Submissions Report

270 Miller Street, North Sydney
Marist Catholic College North Shore
SSD 10473

Submitted to Department of Planning, Industry
and Environment
On behalf of Sydney Catholic Schools

1 November 2021 | 218786

Figure 1 – Proposed childcare fitout floorplan

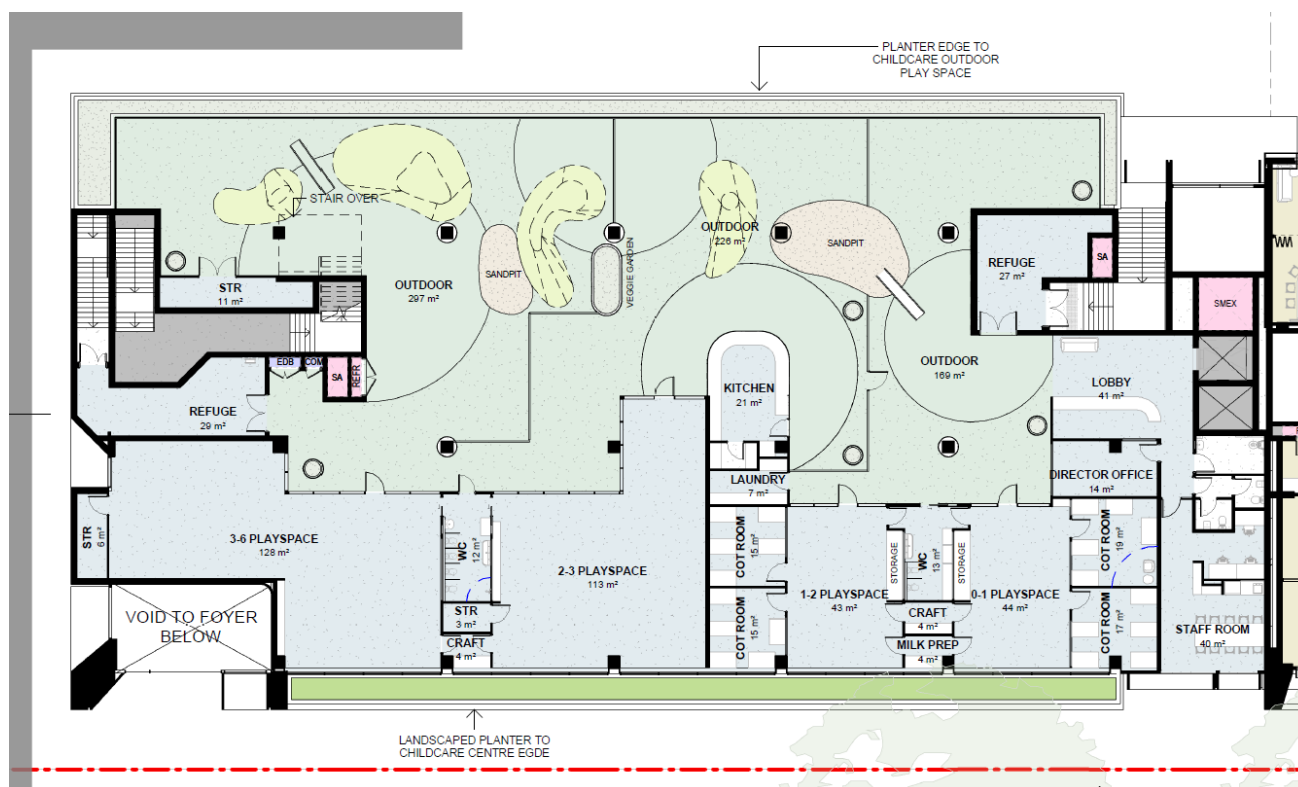
Sydney Catholic Schools seeks to amend the original proposal to include the detailed fitout of the childcare centre as part of the SSD. The proposed fitout design takes a pedagogical approach in line with the Sydney Catholic Early Childhood Services and is consistent with the best practice principles of the *Childcare Planning Guidelines* as outlined in the Architectural Design Response prepared by WMK.

Further natural features and elements be incorporated into the verandah area of the outdoor play space to further enhance the area. This could be achieved by adding a variety of floor type and textures, ridges, mounds and pebbles to mimic the uneven surfaces of an outdoor environment. Other natural elements could also include furniture made of logs, stepping logs and dense indoor planting and green vegetated walls.

These recommendations have been integrated into the design of the childcare fitout. **Figure 1** illustrates the proposed fitout floor plan and is provided in the Architectural Drawings prepared by WMK as attached at **Appendix A**.

Figure 5 – Amended proposed Miller Street building elevation

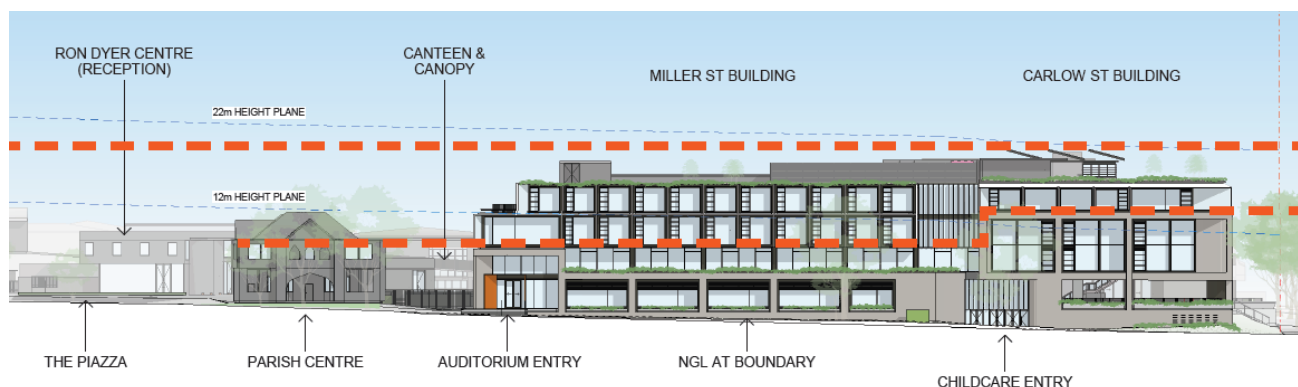
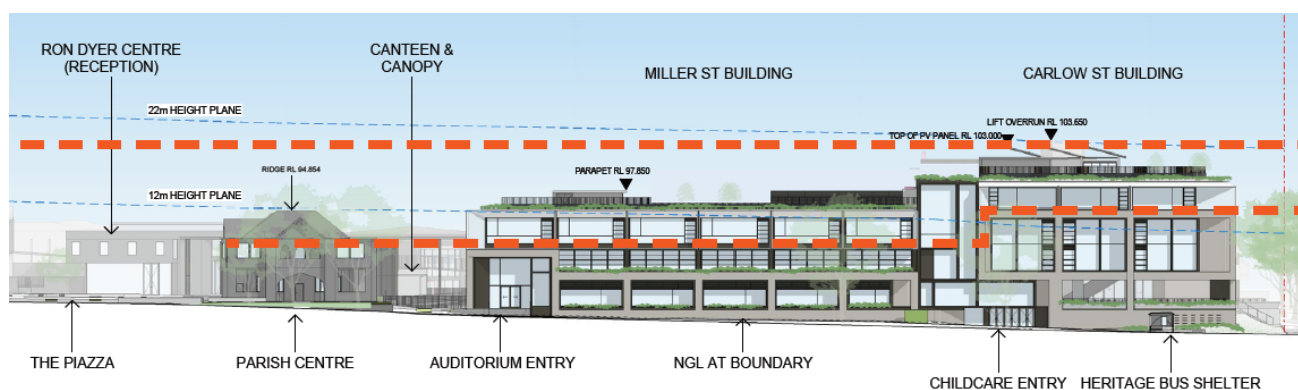
A comparison of the originally proposed Miller Street building and amended Miller Street building is illustrated in **Figure 2** and **Figure 3** and elevations in **Figure 4** and **Figure 5**.

The proposed façade amendments to the Miller Street building in response to concerns raised of the bulk and scale. The proposed amendments provide articulation and modulation to achieve an appropriate bulk and scale and does not result an overwhelming visual impact.

Figure 7 – Amended proposed level 1 service and planter space above kitchen canteen

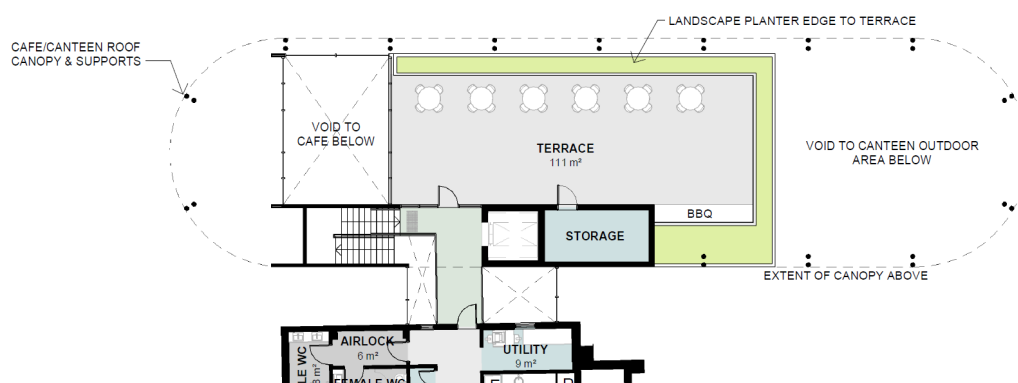
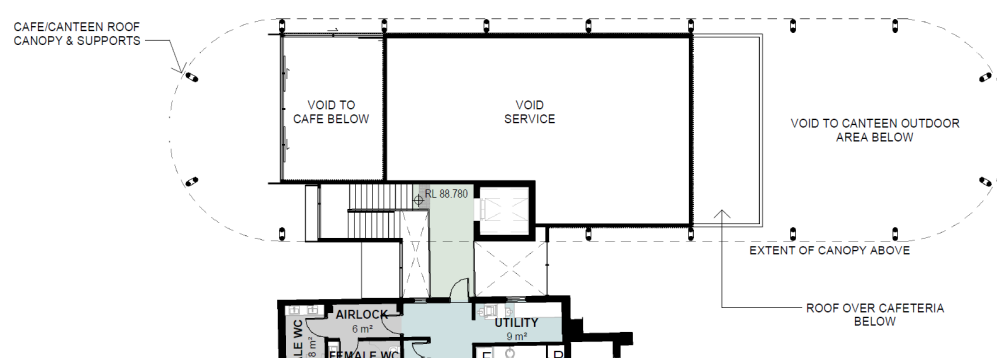
4.1.5 Conversion of Level 1 terrace over the canteen and kitchen to service space

The originally proposed 111m² terrace at Level 1 over the kitchen and canteen has been converted to a non-trafficable service space as illustrated in **Figure 9** and **Figure 10**. This has reduced the overall GFA of the development to 19,797.07m².

Figure 9 – Proposed Miller and Carlow Street landscaped planter frontage

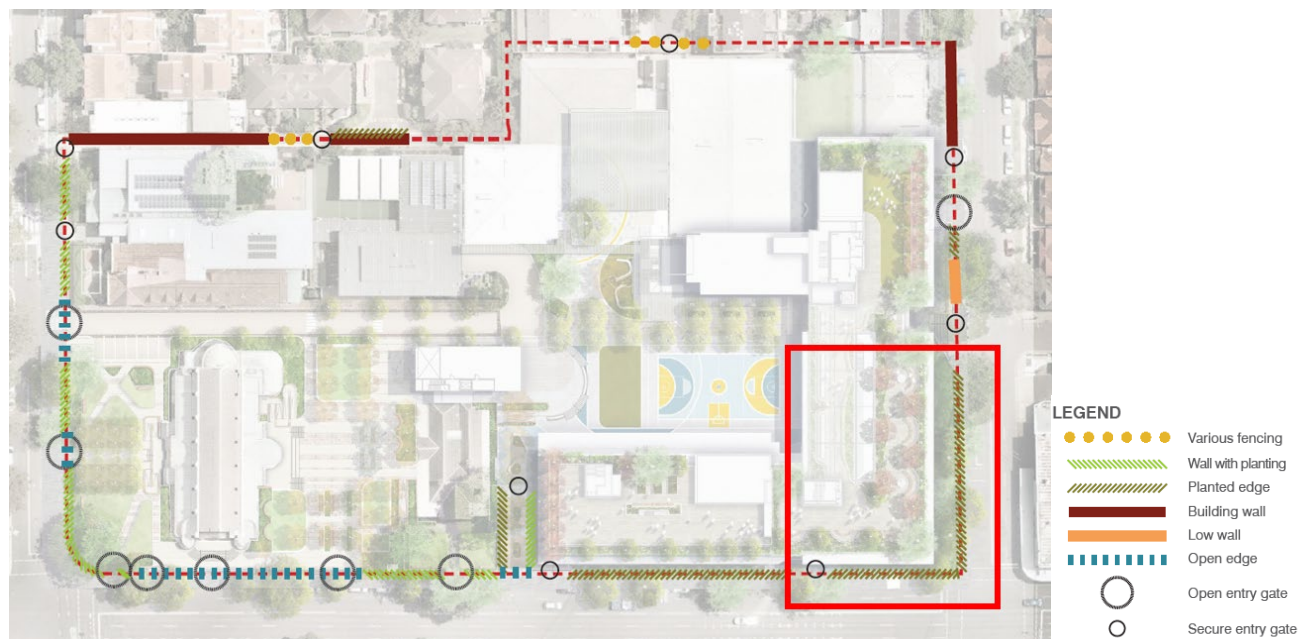
The width of the Miller Street pedestrian path has been expanded by 1.3m, resulting in 4.8m between the building entry and boundary. This is in response to submissions received by the public around the lack of consideration for increased pedestrian use. The landscaping and planter wall design to the street boundary has been adjusted in line with the site boundary to increase the width of the pedestrian pathway, especially behind the heritage bus shelter which occupies the majority of the Miller Street footpath at this point. The proposed landscape treatment within the setback zone to the building facades along both Miller and Carlow Street provides a significant contribution to the streetscape and public domain in comparison to the existing timber boundary fence as outlined in red and shown in the figures below.

Figure 10 – Proposed bike parking locations at basement level

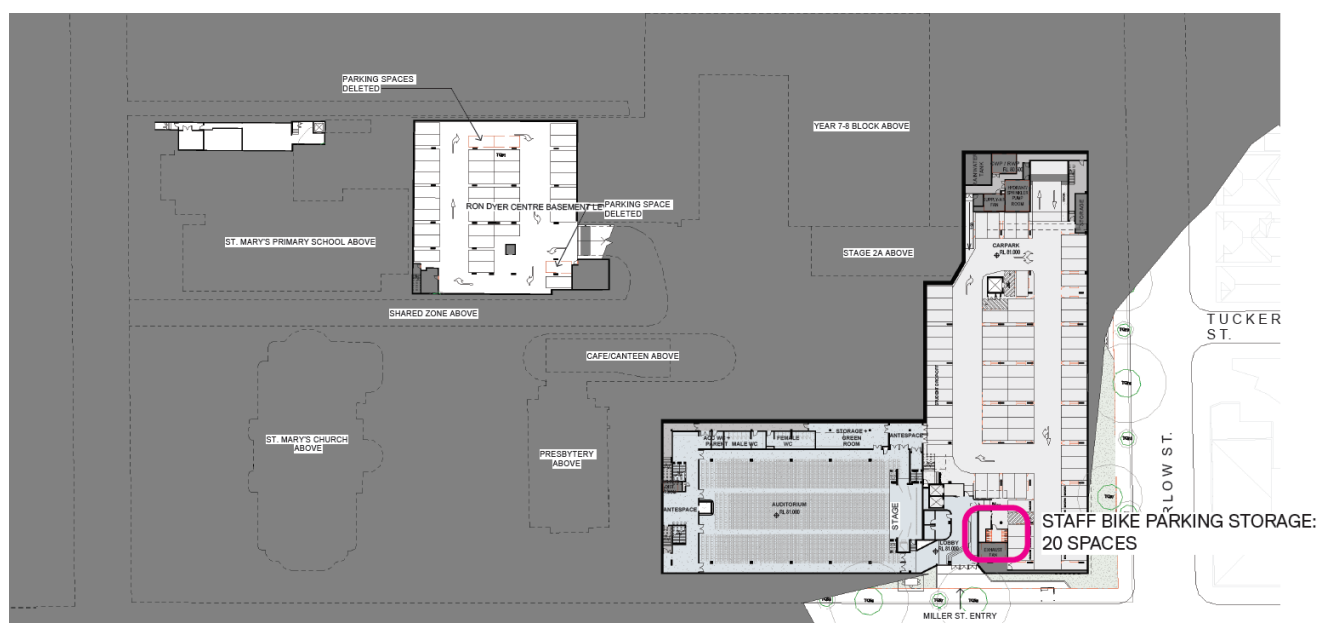
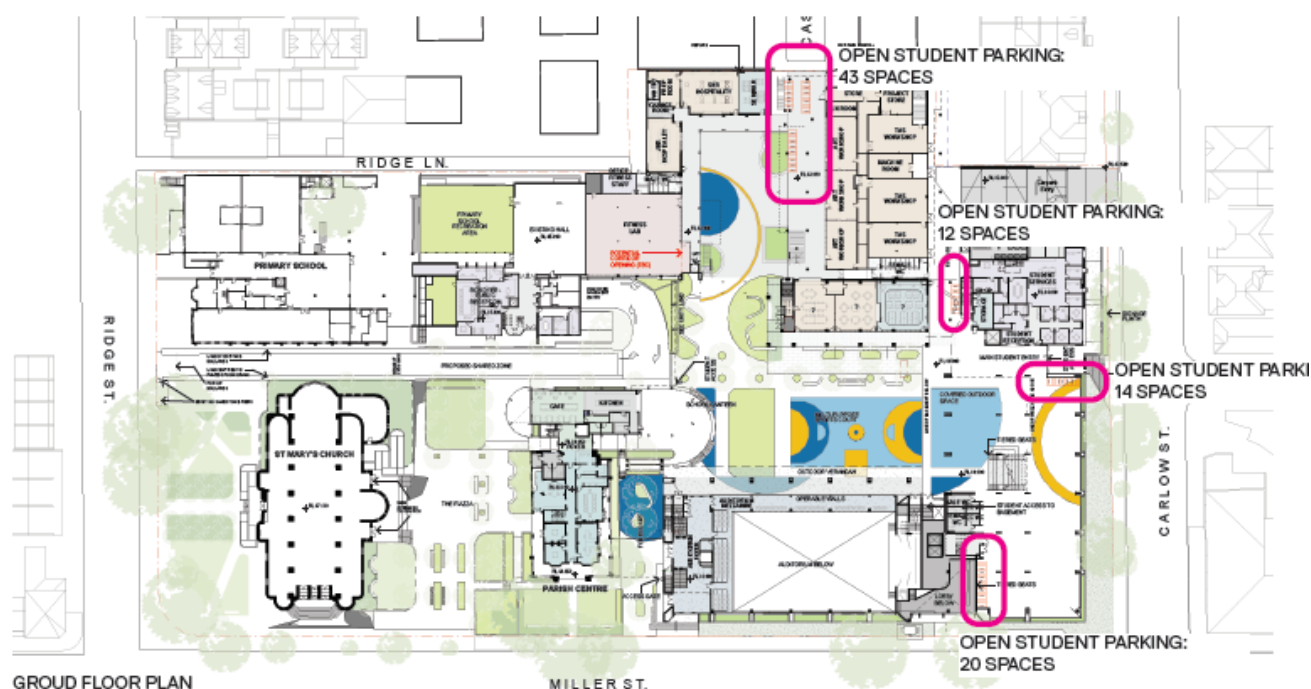
Consistent with TfNSW recommendations, 109 bicycle parking spaces are proposed throughout the site. This encompasses 20 spaces for staff in the basement of the Miller Street building, and 89 spaces for students throughout the ground floor of the school site. These locations are illustrated on page 69 of the Design Statement prepared by WMK (see **Appendix B**) and in **Figure 13** and **Figure 14** below.

Figure 12 – Proposed tower crane location for Stages 2 and 4B

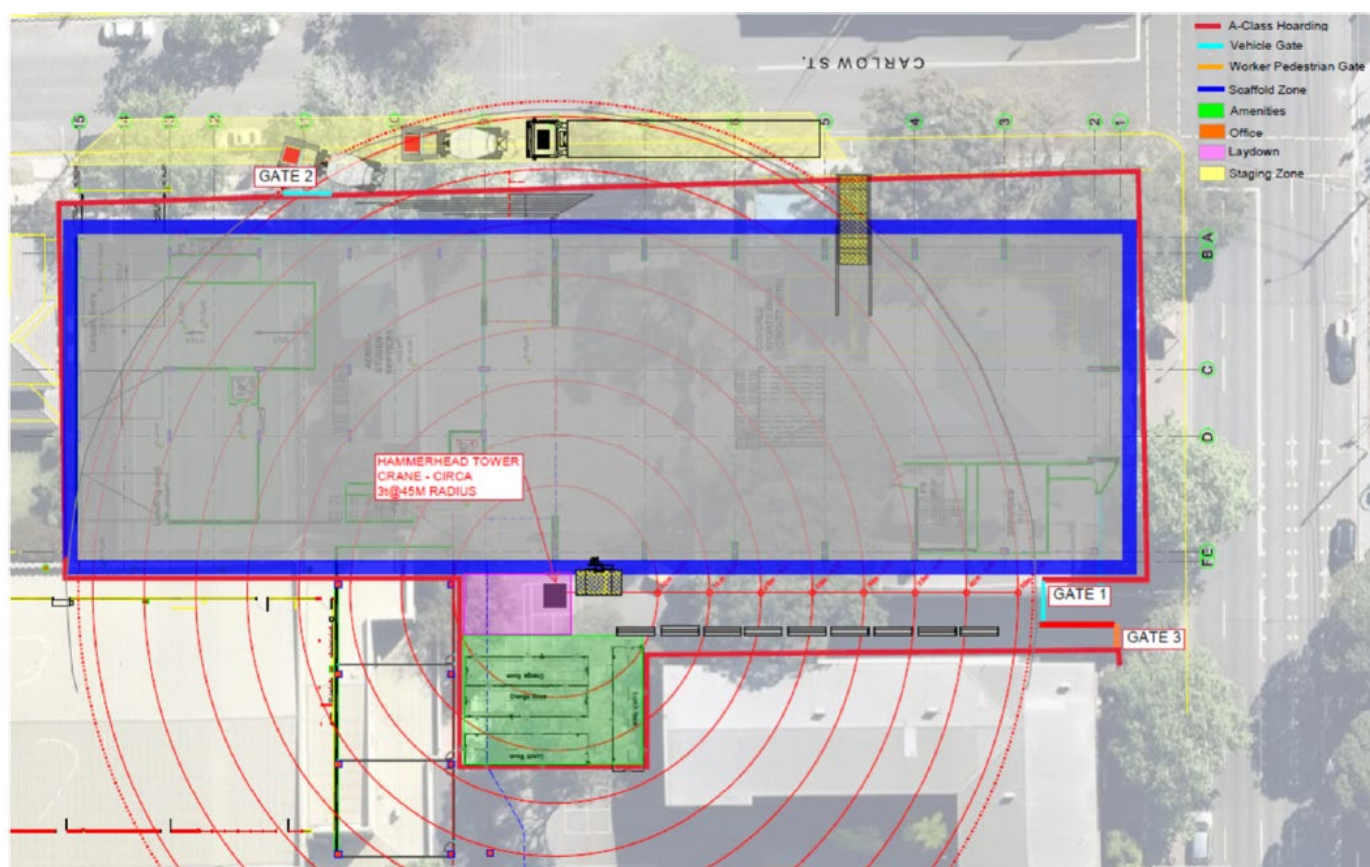
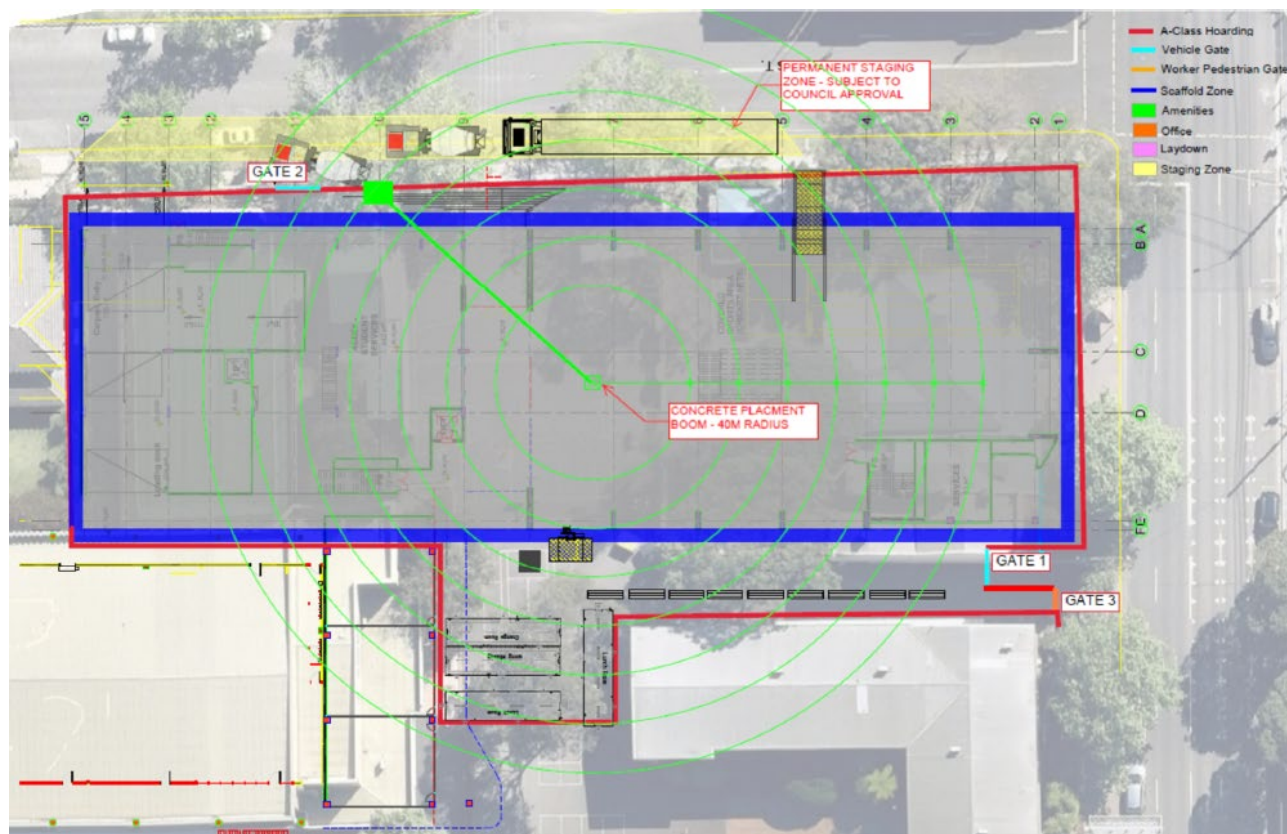
The proposal will result in various crane configurations and arrangements. As illustrated in the figures below, the cranes will be located on site and will not block the laneway. The tower crane for Stage 2B and Stage 4 is proposed to be located at the south of the site. The contractor, in consultation with the geotechnical engineer, will ensure that the set-up location ground conditions are suitable or appropriately engineered and prepared. The concrete placing boom required for Stage 2B and Stage 4 will be located in accordance with **Figure 13**.
